RESPONSE TO REQUEST FOR ADDITIONAL INFORMATION

APR1400 Design Certification

RAI No.: 130-8065

Application Section: 16.1.1 Use and Application - Definitions

LEAKAGE

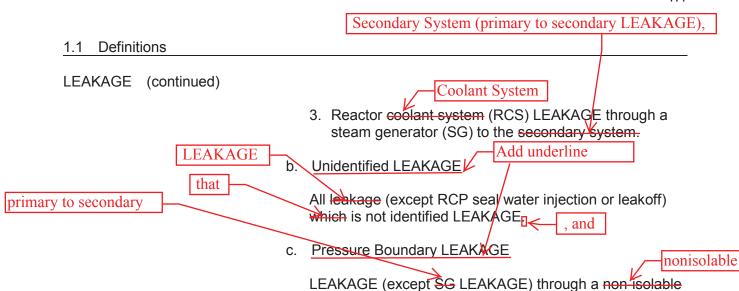
Format, content, and punctuation of the generic TS Section 1.1 definition of LEAKAGE do not conform to the STS Section 1.1 definition. In keeping with NRC policy to maintain standardization of TS requirements, the applicant is requested to change the proposed definition so it is identical to the STS definition.

Add underline

conducted to collection systems

The definition of LEAKAGE will be changed so that it is identical to the STS definition in format, content and punctuation.

The TS Section 1.1 definition of LEAKAGE will be modified as indicated in the Attachment.
